REMARKS

AMENDMENTS TO THE DRAWINGS:

Fig. 2

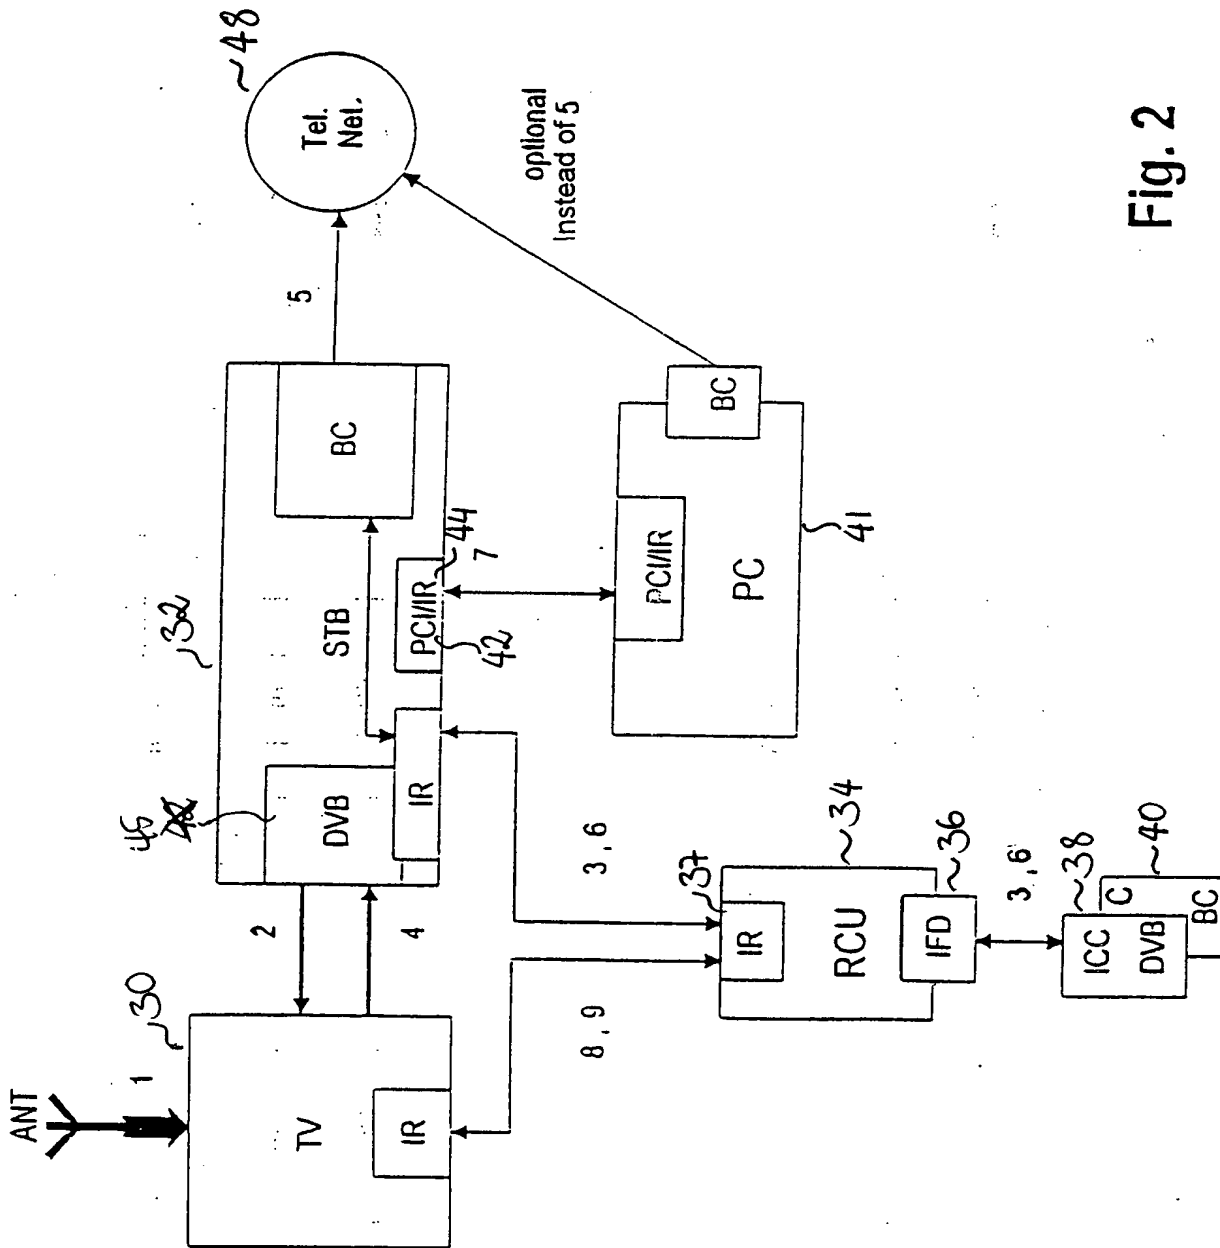
The attached sheet of drawings includes changes to Figs. 1 and 2. The sheets of Figs. 1 and 2 replace the original sheet of Figs. 1 and 2, respectively. In Fig. 1, STB “72” should read “12” in accordance with the Specification. Further, Fig. 1 should be labeled “Prior Art.” In Fig. 2, DVB “42” should read “45” in accordance with the Specification.

Fig. 1

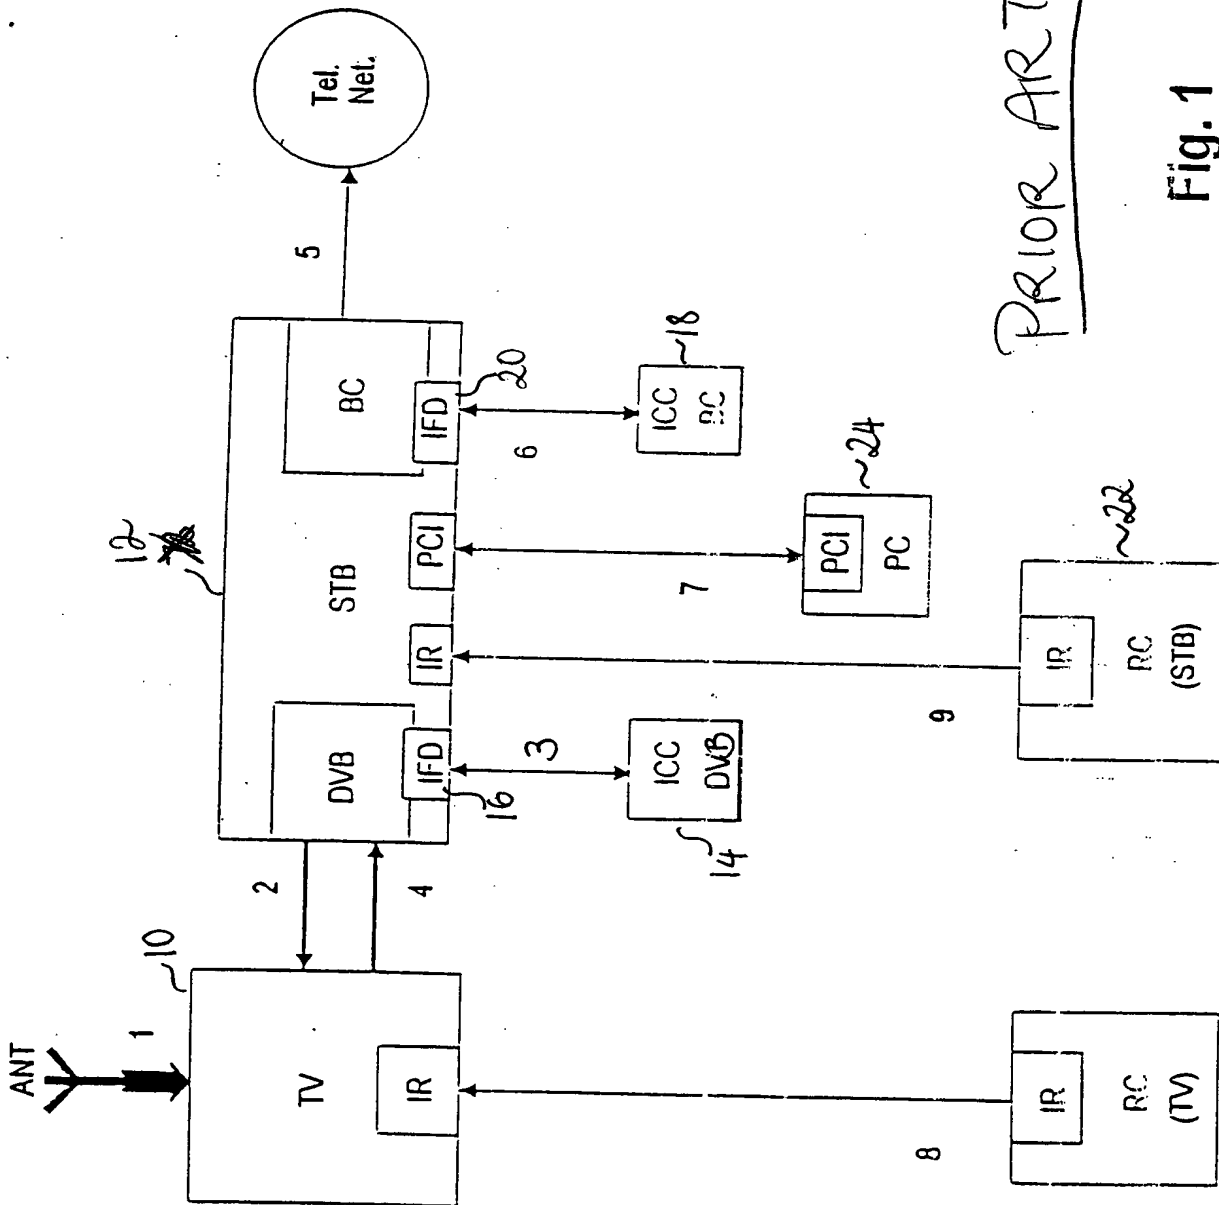
The Drawings were objected to for failing to comply with 37 CFR 1.84(p)(5). Specifically, Fig. 1 was objected to for STB being labeled 72, and no heading of "Prior Art." Applications have amended Fig. 1 so that STB is labeled 12 and there is a heading of "Prior Art" as suggested by the Examiner. No new matter has been added. Specifically, Fig. 2, was objected to for RCU being labeled 34 while it was referred to as 42 in the Specification. For this and other typographical errors, Fig. 2 has been amended, and, the Specification has been amended so that the description of Fig. 2 is consistent with the drawing of Fig. 2. No new matter has been added. Accordingly, Applicants submit that the Drawings have been amended in accordance with the Examiner's requests and all objections to the Drawings have been overcome. Withdrawal of the objections to the Drawings is respectfully requested.
